CITY OF GEARHART PLANNING COMMISSION
City Staff Report for CKI /Gronmark Land Partition
Carole Connell, City Planner
March 1, 2018

REQUEST: Jim Gronmark requests approval of a two-lot Land Partition to re-configure an existing parcel line that was created by deed in 2015.

FILE NUMBER: File# 18-002P Gronmark

2011 Gearhart Wetland Inventory Map

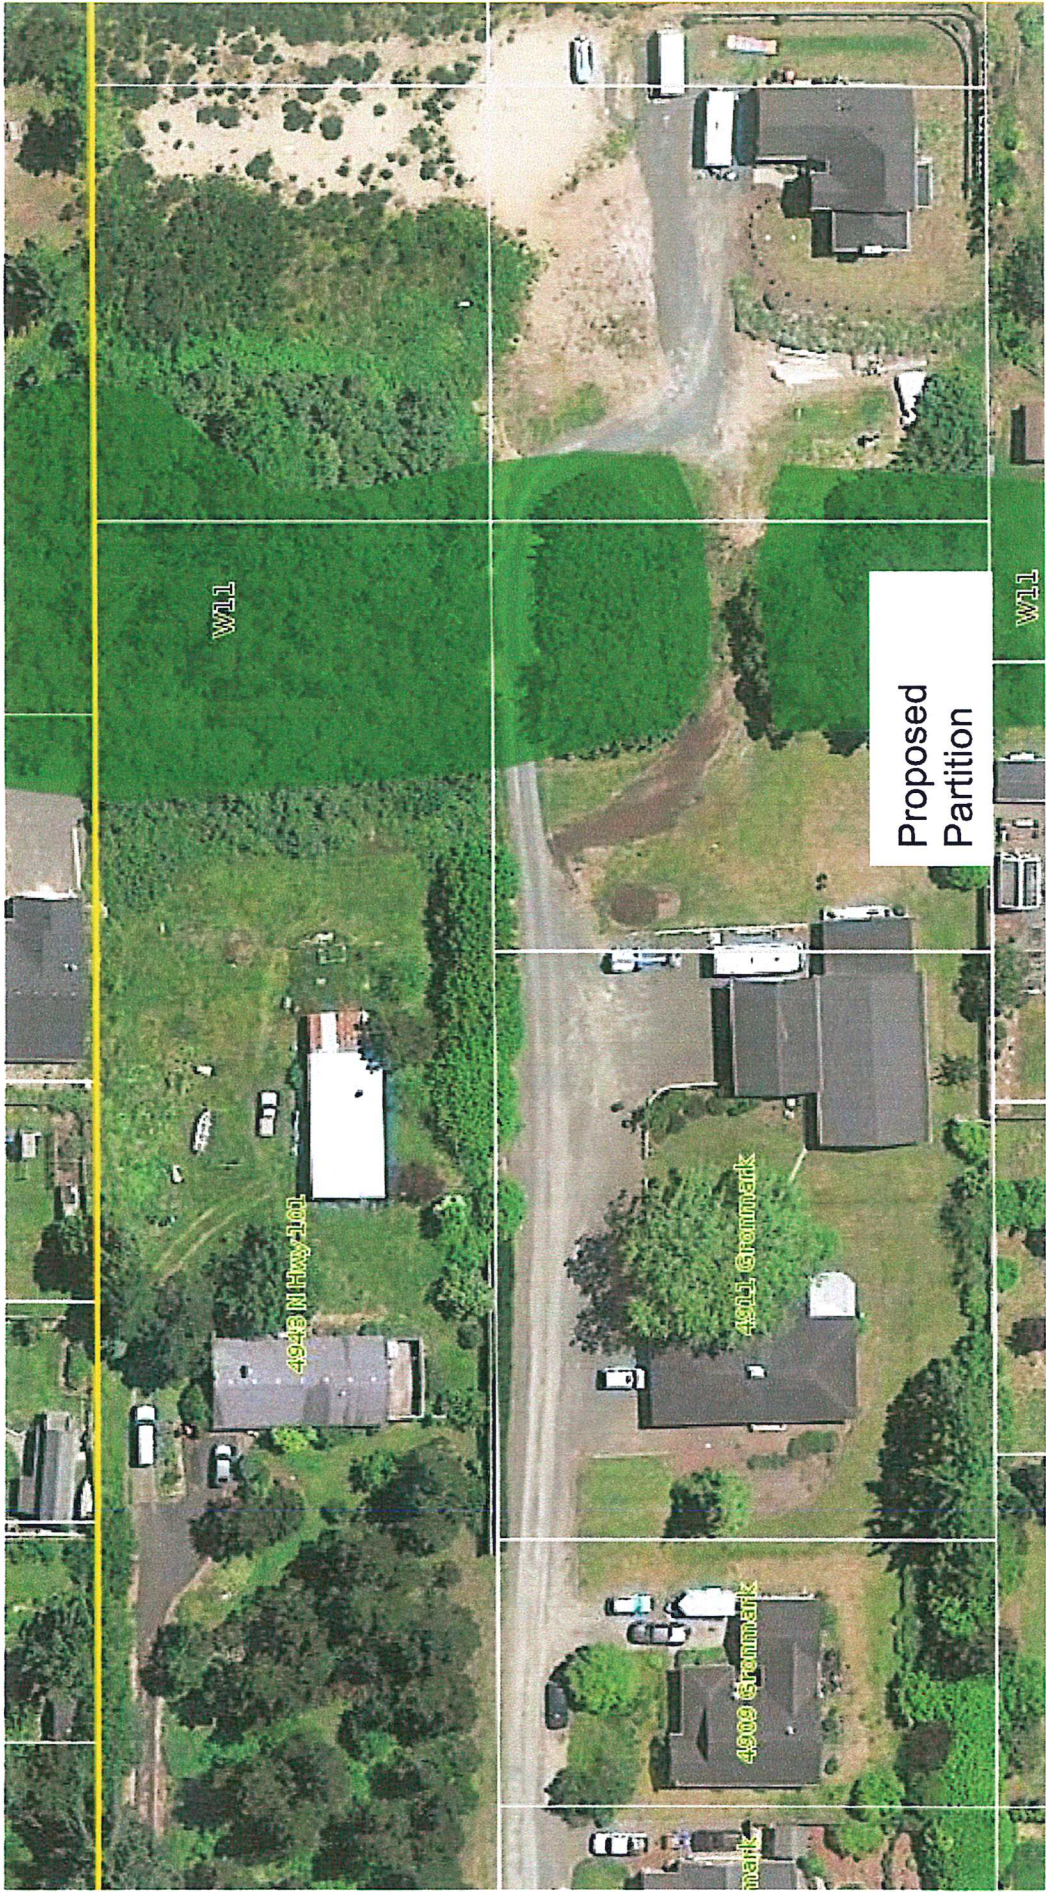
FINDINGS: The City finds that the official Gearhart Local Wetland Inventory LWI map illustrates a wetland on the east side of the parcel. A wetland determination has been made. The proposed partition provides buildable area for Parcel 2 that is outside of the designated wetland.

5. Prior to development, Parcel 2 will be required to flag the approved wetland delineation. Site wetlands shall be preserved from damage or destruction resulting from clearing, grading or dumping of earth, waste or stumps. A future building permit on Parcel 2 shall be accompanied by proof of the minimum 25’ setback from the wetland.
